Project: 20-01405-041 Private Fuel Storage Facility

Title: Evaluation of PFS Earthquake Analyses for SER on PFSF License Application (SAR)

Scientific Notebook 353
December, 18, 2001
Entry By: John A. Stamatakos

Purpose: To document comparison of Private Fuel Storage Facility (PFS) probabilistic seismic hazard results (PSHA) to other PSHA results for the western United States.

Figure 3. Mean hazard curves for selected cities.

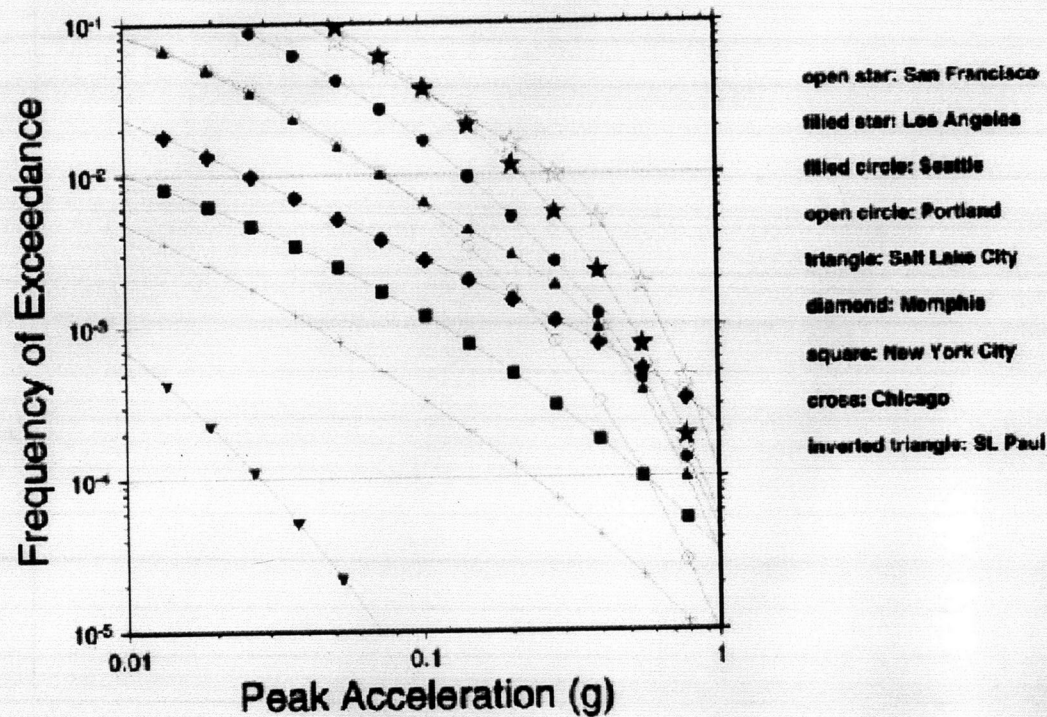
The following figure (figure 3) is from that paper. From the figure I digitized values for the Salt Lake City Hazard curve, and converted them to cm/s/s $1\text{ g} = 9.8\text{ m/s}^2 = 980\text{ cm/s}^2$.

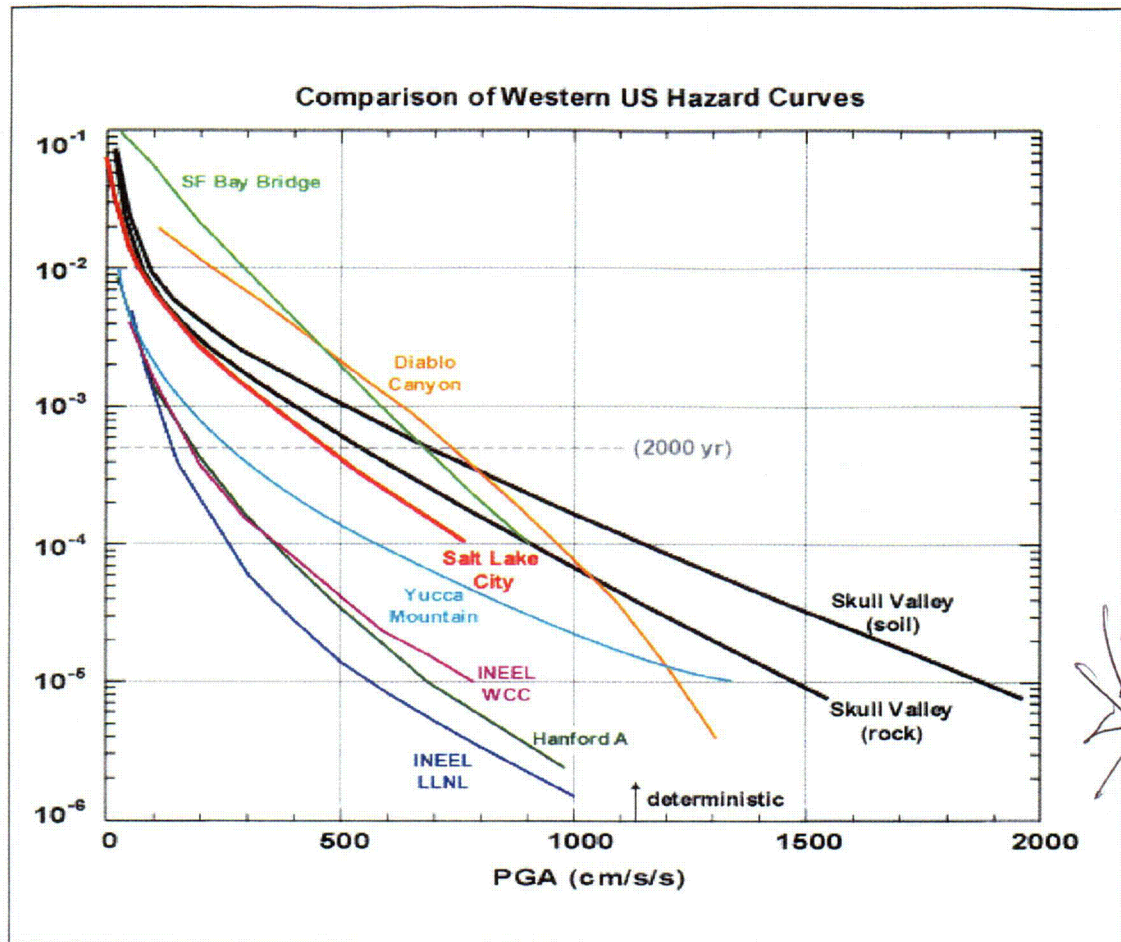
3. I then plotted all the data (using Kaleida Graph, version 3.09) to produce the following graph.

The results show the conservative nature of the applicant's source characterization and PSHA results presented in the SAR. This conservatism is evident when the results are compared to PSHA results for other sites in Utah, especially those in and around Salt Lake City. This a comparison shows that the seismic hazard in Skull Valley was calculated by the applicant to be higher than seismic hazard estimates that have been performed for sites at, or near, Salt Lake City, despite the fact that fault sources near Salt Lake City are larger and more active than fault sources near the PFS site. For example, the results of the applicant's PSHA for Skull Valley (Geomatrix Consultants, Inc., 2001a) suggest that it is 1.5 times more likely that a ground motion of 0.5g horizontal peak ground acceleration or greater will be exceeded at the PFS site (assuming hard rock site conditions), than at Salt Lake City, based on the USGS National Earthquake Hazard Reduction Program (Frankel et al., 1997).

Similarly, the 2000-yr horizontal peak ground acceleration for Skull Valley (soil hazard) as estimated by the applicant, is higher than the 2500-yr ground motions for the nine sites along the Wasatch Front that were evaluated as part of the Utah Department of Transportation I-15 Reconstruction Project (Dames & Moore, Inc., 1996). The ground motions estimated by the applicant in Skull Valley are higher than those for the I-15 corridor, despite the close proximity of Salt Lake City to the Wasatch fault, which has a slip rate nearly ten times larger than the Stansbury or East Faults (cf., Martinez et al., 1998; Geomatrix Consultants, Inc., 1999a) and is capable of producing significantly larger magnitude earthquakes than the faults near the PFS Facility site in Skull Valley (cf., Machette et al., 1991; Geomatrix Consultants, Inc., 1999a).

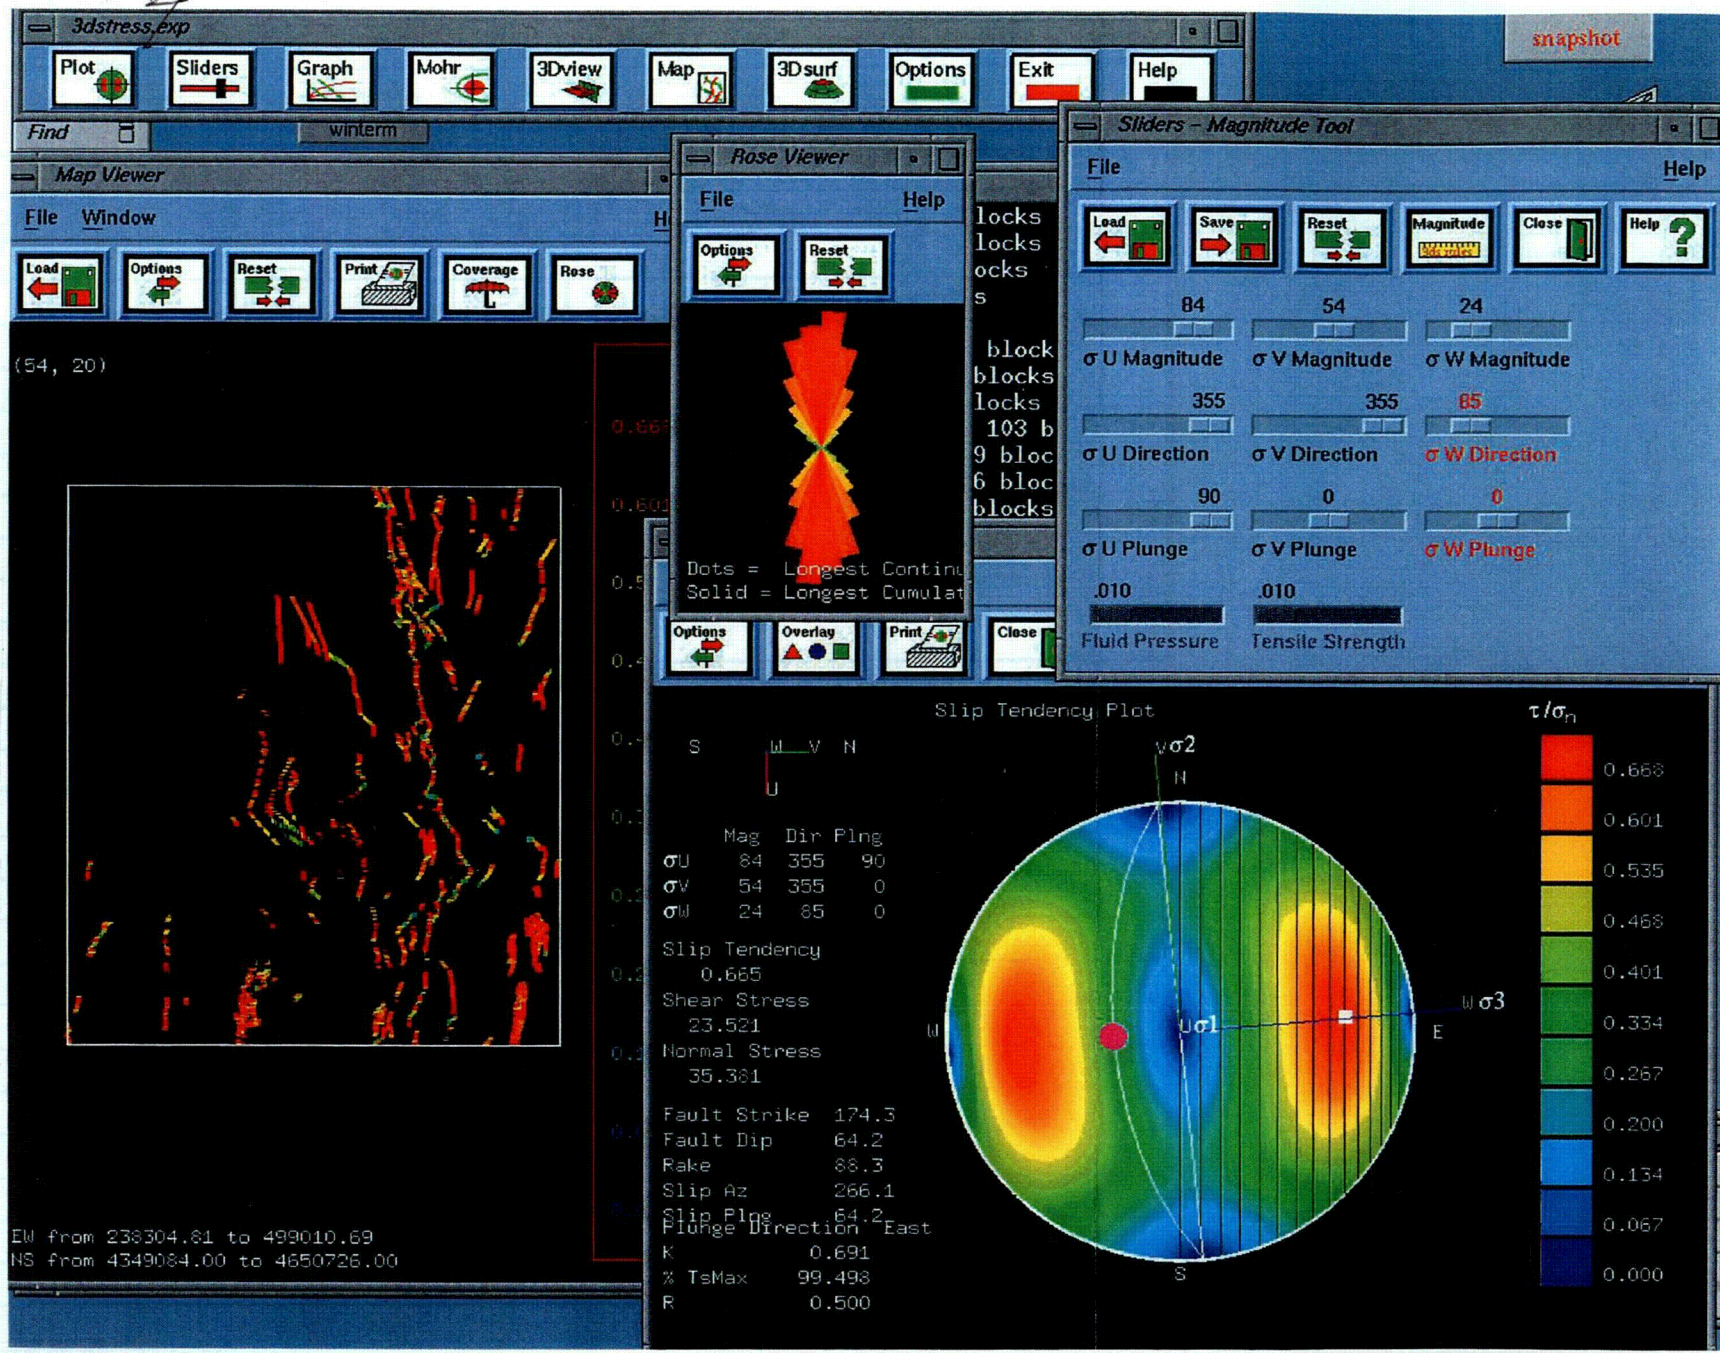
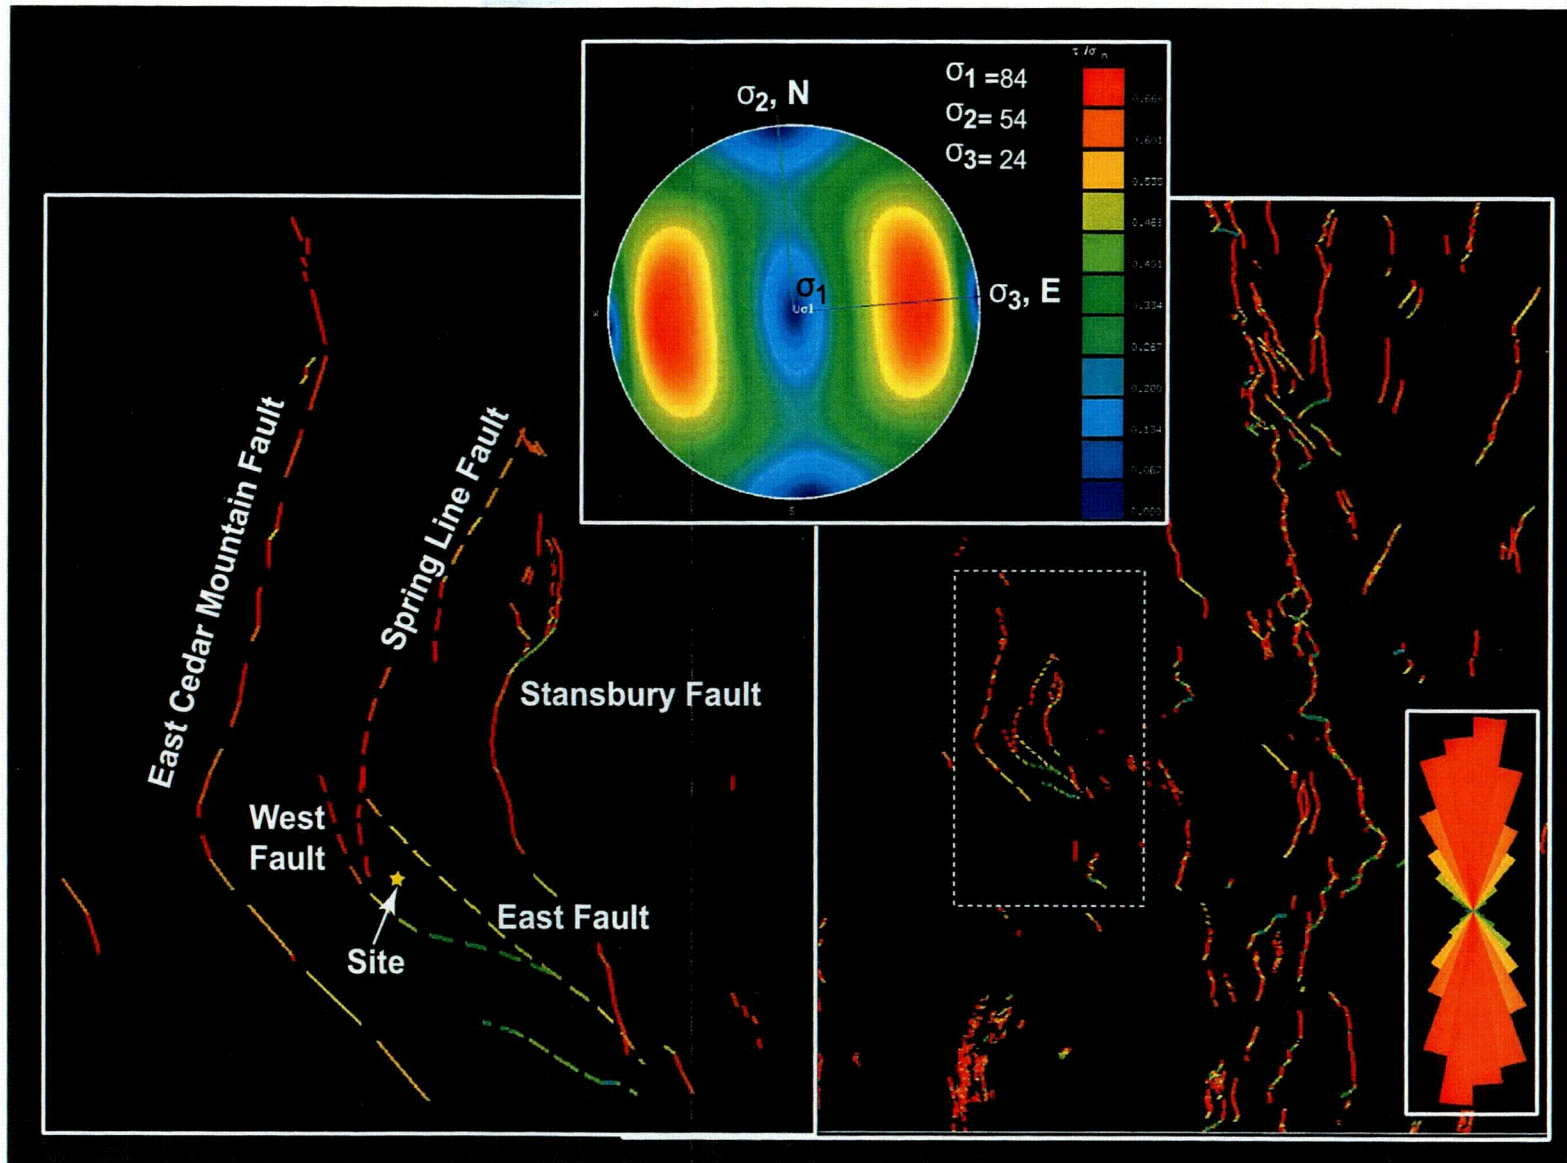
The following two pages are figures from 3DStress™ that summarize the slip tendency results. The first figure is an electronic snapshot of the screen showing the results of the analysis. The second figure is a summary shot showing a close-up of Skull Valley along site the central Utah regional map.

The slip tendency analysis shows that segments of the East fault and the East Cedar Mountain fault nearest the PFS site have relatively low slip tendency values compared to segments farther north in Skull Valley. As discussed in the following sections on site-to-source distances and maximum magnitudes, these results indicate that the seismic source characterization of the PSHA study conducted by Geomatrix Consultants, Inc. (1999a, and 2001a) is conservative. Three areas of conservatism are the distribution of site-to-source distance, maximum magnitude earthquakes, and potential of the West fault as a seismogenic source (discussed in Stamatakos et al., 1999).

Results of the slip tendency analysis indicate that fault segments with approximately North-South strikes (azimuth = 175°) are optimally oriented for future fault slip. Faults with north northeast-south southwest strikes have high slip tendency values. In contrast, fault segments with northwest-southeast strikes, such as the East fault near the PFS Facility site and the southern segments of the East Cedar Mountain fault also near the PFS Facility site, have relatively low slip tendency values. Therefore, these fault segments are less likely to slip in the future than fault segments further from the site. Fault rupture close to the site greatly influence the seismic hazard. The closer the earthquake is to the site, the larger the resulting ground motions compared to an equal magnitude earthquake on a fault segment farther away from the site.

In the site-to-source distributions used in the ground motion attenuation equations, Geomatrix Consultants, Inc. (1999a) assumed uniform distributions of earthquake ruptures along active fault segments. Given the slip tendency analysis described above, this assumption by Geomatrix Consultants, Inc. (1999a) is conservative. The staff concludes that seismic source models that incorporate slip tendency would result in a lower ground motion hazard than the one developed by the applicant.

The slip tendency results suggest that Geomatrix Consultants, Inc. (1999a) may have overestimated the maximum magnitude of the East and East Cedar Mountain faults near the PSFS site. In the SAR, the applicant first developed conceptual models of the physical dimensions of fault rupture—either rupture area or trace length of surface fault rupture—based on the geologic record (Geomatrix Consultants, Inc., 1999a). Second, the applicant developed distributions of maximum magnitudes for each active fault using empirical scaling relationships developed from the magnitudes and associated rupture dimensions of historical earthquakes (e.g., Wells and Coppersmith, 1994). In developing the fault segment models, the applicant conservatively assumed that the entire mapped length of the surface trace length represents active fault segments. Thus, these maximum fault dimensions produce conservative estimates of maximum magnitude.

The slip tendency analysis indicates that parts of the East and East Cedar Mountain faults near the

PFS Facility site have relatively low slip tendency values. Thus, these faults may be smaller than in the fault models used by the applicant to estimate maximum magnitude. Fault rupture models developed using slip tendency analysis would therefore lead to fault segment models with smaller rupture dimensions (length or area) than those used by Geomatrix Consultants, Inc. (1999a). Because distributions of maximum magnitude for each active fault are derived from empirical scaling relationships of rupture area or rupture length (e.g., Wells and Coppersmith, 1994), application of the slip tendency analysis would thereby result in smaller predicted maximum magnitudes than those developed by the applicant. Smaller maximum magnitudes would reduce the overall ground motion hazard.
